CITY OF CORCORAN  
**Corcoran Planning Commission Agenda**  
**October 6, 2022 - 7:00 pm**

<b>Planning Commission Meeting:</b> October 6, 2022	<b>Prepared By:</b> Kendra Lindahl, AICP
<b>Topic:</b> Rezoning, Preliminary Plat and Preliminary PUD Development Plan for “Corcoran Farms Business Park” (PID 26-119-23-13-0006) (city file no. 22-044)	<b>Action Required:</b> Recommendation

Figure 3 - Proximity to Residential

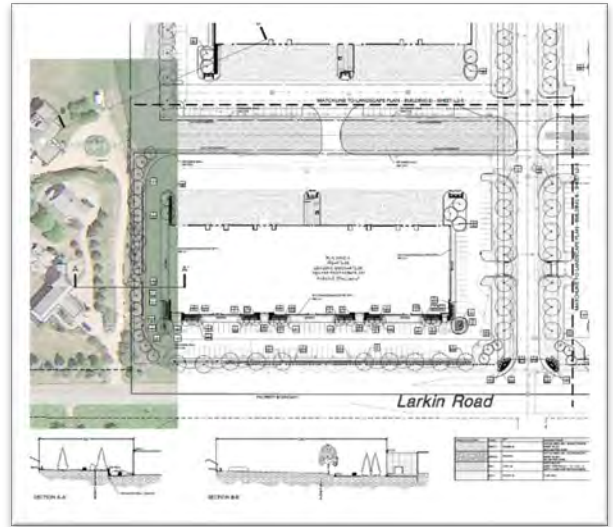
Section 1060.060 of the Zoning Ordinance says “loading areas established after March 23, 2004 shall be prohibited within 300 feet of residentially zoned or guided property unless completely screened by an intervening building. Loading areas not requiring screening by an intervening building shall be screened from adjacent residentially zoned or guided property by the use of berms, fences, or walls to provide 100 percent opacity to a height of at least 10 feet. The height of the screening shall be measured from the grade of the loading areas.”

The plans do not comply with this requirement (as shown on Figure 3). Building A is approximately 60 feet from the residential property line to the west and Building D is approximately 140 feet from the residential property to the west. Due to the site constraints caused by the location Larkin Road, the intersection with Blue Bonnet, the gas line easement and the wetlands, the applicant indicates that the building could not be reoriented to screen the loading docks with an intervening building. These issues do create challenges that make reorienting the building difficult, but staff does not believe enough has been done to screen the loading docks from the existing residential properties to the west.

The plans do show a 36-foot high wing wall extending from the west elevation of the building to screen the loading docks. A retaining wall is provided near building A and landscaping is provided along the west property line.

Staff notes that the 50-foot wide gas line easement adjacent to the west lot line of Building D limits the amount of landscaping that can be provided under the current plan.

The Planning Commission should discuss the PUD flexibility requested. If the Planning Commission finds that additional landscaping is required to screen the loading docks, Buildings A and D would need to be reduced in width to provide increased green space for planting. Staff believes at least 30 additional feet of green space would be required along the western property line to provide a double row of screening. This would require a reduction in the size of both Building A and Building D.

Figure 6 - Potential Changes

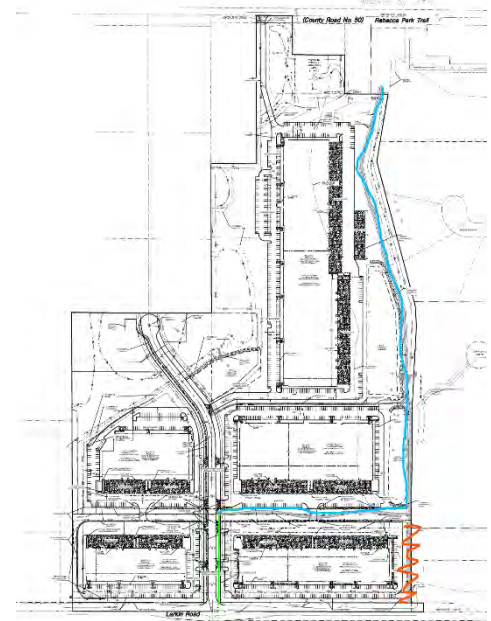
Staff believes that the trail connection needs to be revised to connect the trail at Blue Bonnet and Larkin Road. The plans show the trail along the gas line easement and it could be modified to add a trail connection from this easement south on the east side of Blue Bonnet south to Larkin (green line on Figure 5). However, staff notes that this is an area where a reduced setback is requested and this could result in less landscaping unless the parking and building B and C were shifted east and the trail to the east is eliminated (red lines on Figure 5).

Additionally, the City requires a sidewalk on one side of all public streets. The sidewalk shall remain on the west side of the new public street (opposite the trail).
